| Intersection ID: 8037 | Main Street: AUSTIN_DR | Cross Street: ELGYWOOD_LN | Location:              | NW                   |
| ADA ID: E2A2BF9611C7  | Ramp Type: Para        | Initial Pass/Fail: Fail   | Overall Compliance: No | Severity Score: 12.5 |

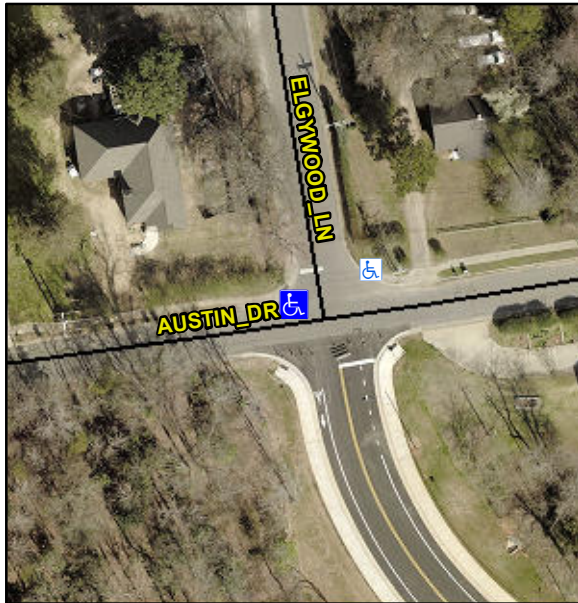
**CURB GAP 1.0, LT RP < 5%**

### R304.3.2

| Compliance | Description          | Data | Compliance | Description                 | Data |
|------------|----------------------|------|------------|-----------------------------|------|
| Yes        | Ramp Slope LT (%)    | 0.6  | No         | Ramp Slope RT (%)           | 9.9  |

### Remove & Replace Entire Ramp.
